GENERAL INFORMATION

Request	-	Special Use Permit for Gasoline and Fuel Sales
Location	-	5305 and 5321 Monroe and 4700 Nantuckett (2 parcels)
Applicant / Developer	-	Skilken Gold Development, LLC 4270 Morse Rd Columbus, OH 43230
Owner	-	Grimon Properties Limited 4442 Alexis Road Toledo, Ohio 43623
Tenant	-	Sheetz, Inc. 5700 Sixth Avenue Altoona, PA 16602
Engineer	-	Civil & Environmental Consultants, Inc. 8800 Lyra Drive Suite 300 Columbus, OH 43240

SPECIAL USE PERMIT
TOLEDO CITY PLAN COMMISSION
REF: SUP25-0036
DATE: November 6, 2025
TIME: 2:00 P.M.

SKILKENGOLD DEVELOPMENT, LLC
SHEETZ CONVENIENCE STORE
SPECIAL USE PERMIT
 5305 MONROE STREET
 CITY OF TOLEDO

SITE PLAN

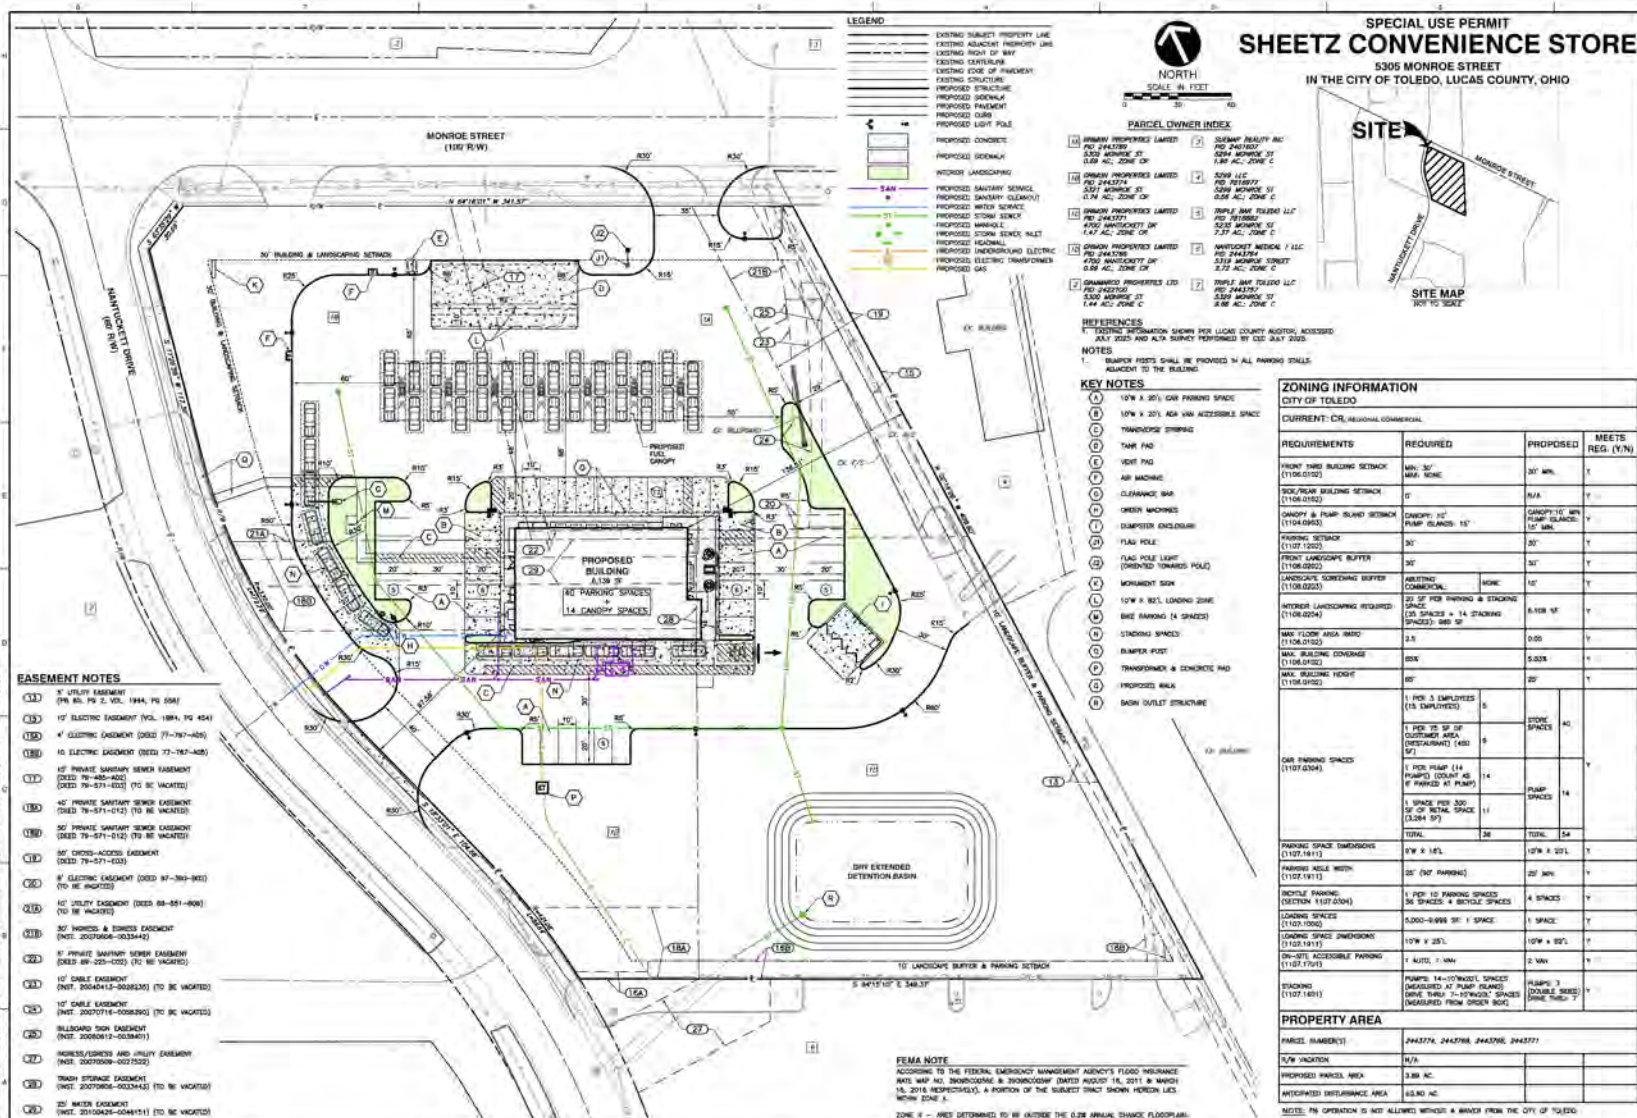
The site will have two (2) access drives, one (1) from Monroe Street and one (1) from Nantuckett Drive. The primary façade of the building will face Monroe Street and the majority of the parking will be located along the north, east and west building facades. A drive-thru is located along the western and southern portions of the site, with vehicle stacking beginning at the northwest portion. There is an existing sidewalk along Monroe Street, and the applicant is proposing to install a sidewalk along Nantuckett Drive.

Off-street parking is allowed according to TMC§1107.0304. The maximum number of parking spaces permitted is determined by the uses at the site, which include: gasoline and fuel sales which are allowed to have one (1) parking space per pump plus one (1) per 200 square feet of building area, and for the sit-down restaurant, one (1) per two (2) employees plus 1 per 75 square feet of customer area. The site plan depicts seven (7) double sided gas pumps, and based on information provided in the submittal, a maximum of forty-two (42) marked parking spaces are allowed in addition to parking spaces at the gas pumps. The site plan meets this requirement.

Bicycle parking is required per TMC§1107.0304 Schedule A at a rate of one (1) bicycle parking slot per 10 parking spaces. Based on the forty (40) marked parking spaces provided, four (4) bicycle slots are required. The site plan illustrates that four (4) bicycle slots will be provided along Nantuckett Drive and connected to the proposed Nantuckett Drive sidewalk. The site plan meets this requirement.

Accessible off-street parking is required per TMC§1107.1700 at a rate of one (1) car accessible parking space, with at least a five-foot (5') wide aisle abutting the designated space, and one (1) van accessible parking space, with at least an eight-foot (8') wide aisle abutting the designated parking space, are required when there are twenty-six (26) to fifty (50) total parking spaces. The proposed site plan meets this requirement as two (2) van accessible parking spaces are provided.

30. Free air shall be provided and maintained during operating hours of the station per TMC§1104.0903(D). Two (2) air stations are illustrated on the site plan. These air stations shall be free of charge.

31. Should charging stations for electric vehicles be provided, they shall meet the requirements of TMC§1105.1300.
32. Parking is allowed up to the amount stated in TMC§1107. Applicant is permitted a maximum of forty-two (42) spaces and have provided forty (40) marked spaces. **Acceptable as depicted.**

33. Bicycle parking slots shall be provided per TMC§1107.0304 Schedule A for the proposed gas station and restaurant uses. Four (4) bicycle parking slots are required. The site plan depicts four (4) bicycle parking slots and meet the requirement. **Acceptable as depicted.**

34. Accessible off-street parking spaces shall be provided per TMC§1107.1700. A minimum of one (1) car accessible space and one (1) van accessible space is required for the site. The site plan depicts two (2) van accessible spaces. **Acceptable as depicted.**

Civil & Environmental
Consultants, Inc.

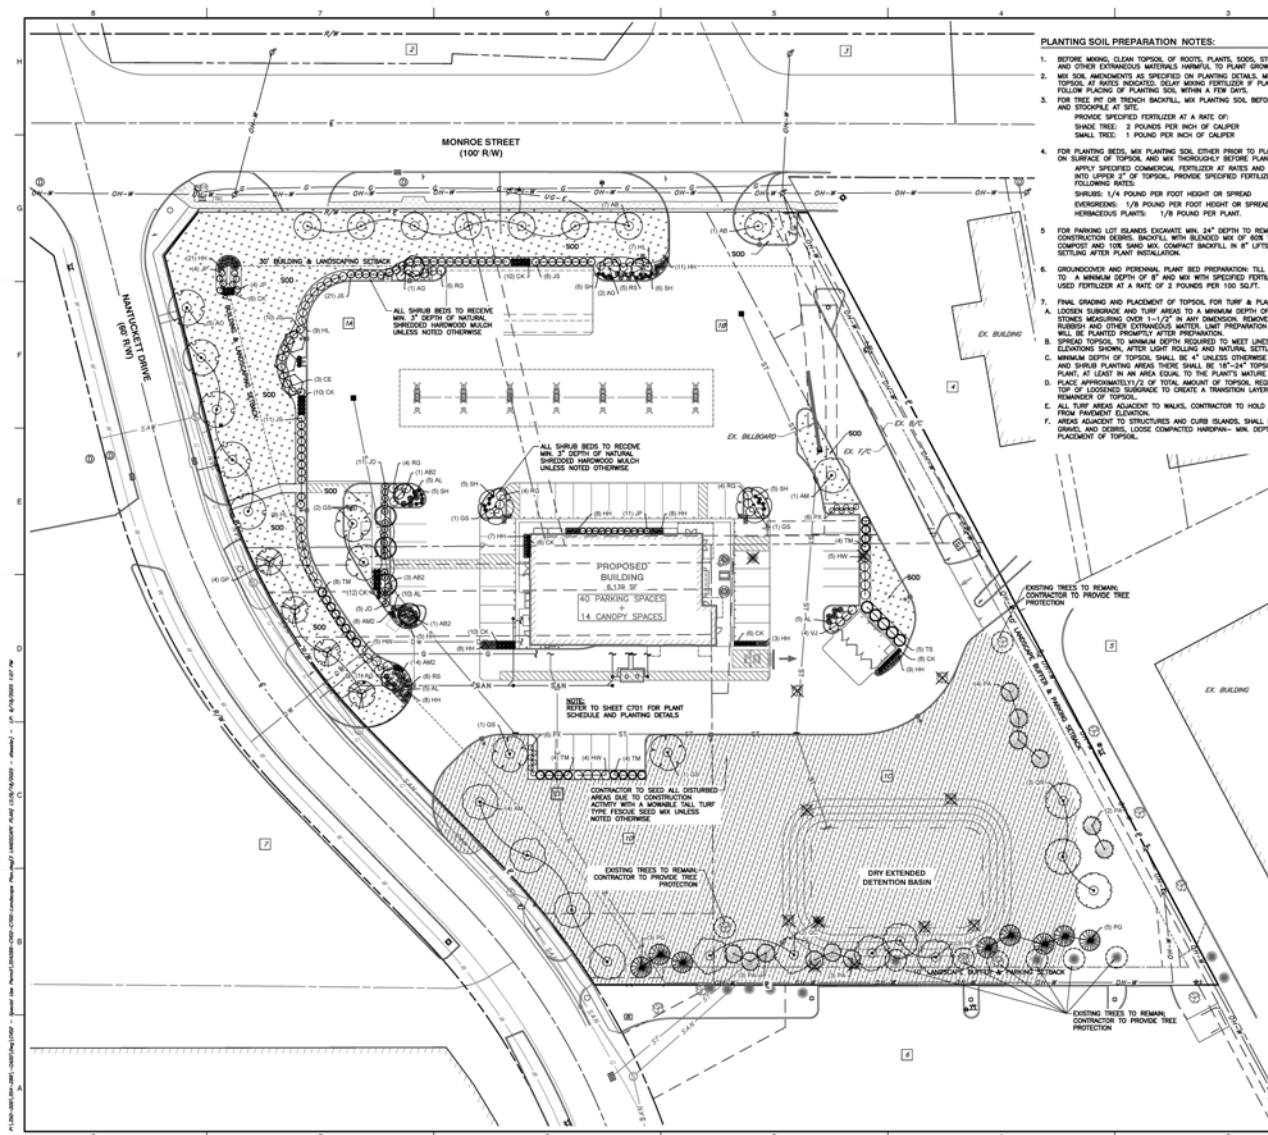
A minimum 15-foot (15') wide frontage greenbelt per TMC§1108.0202, is required along both Monroe Street and Nantuckett Drive. This greenbelt must contain at least one (1) tree for every thirty feet (30') of frontage. A total of twenty-two (22) trees are required for the site. The landscape plan depicts a total of twenty-one (21) trees with eight (8) along Monroe Street and thirteen (13) along Nantuckett Drive. Additionally, a shrub row is depicted along the perimeter of the parking lot to shield headlights. One (1) additional tree is required in the frontage greenbelt as a condition of approval.

Interior landscaping for parking lots is required per TMC§1108.0204 at a rate of two (2) canopy trees and six (6) shrubs for each ten (10) parking spaces within the parking lot. With forty (40) designated parking spaces proposed, eight (8) canopy trees and twenty-four (24) shrubs are required. The submitted landscape plan complies with this requirement as it depicts ten (10) trees and shrubs in excess of this amount. The interior parking lot landscaping is acceptable as depicted.

Interior site landscaping per TMC§1108.0205 is required for commercial properties, in addition to other landscape requirements. This includes: one (1) 2-inch caliper tree for every 1,000 square feet of building coverage, foundation plantings along all portions of the building that are visible from a public right-of-way, and landscaping at major building entrances. The proposed building is 6,139 square feet, which requires seven (7) trees. The landscape plan depicts the required trees, foundation plantings and landscaping at building entrances and therefore complies with these standards.

- a. A fifteen-foot (15') frontage greenbelt along Monroe Street and Nantuckett Drive is required per TMC§1108.0202. **Not acceptable as depicted. One (1) additional tree is required in the frontage greenbelt.**

- d. Interior parking lot landscaping is required per TMC§1108.0204. Eight (8) canopy trees and twenty-three (24) shrubs are to be provided. Trees and shrubs in excess of this amount are provided. **Acceptable as depicted.**

- e. Interior site landscaping is required per TMC§1108.0205. Seven (7) trees, landscaping at major building entrances, and foundation plantings are required. **Acceptable as depicted.**
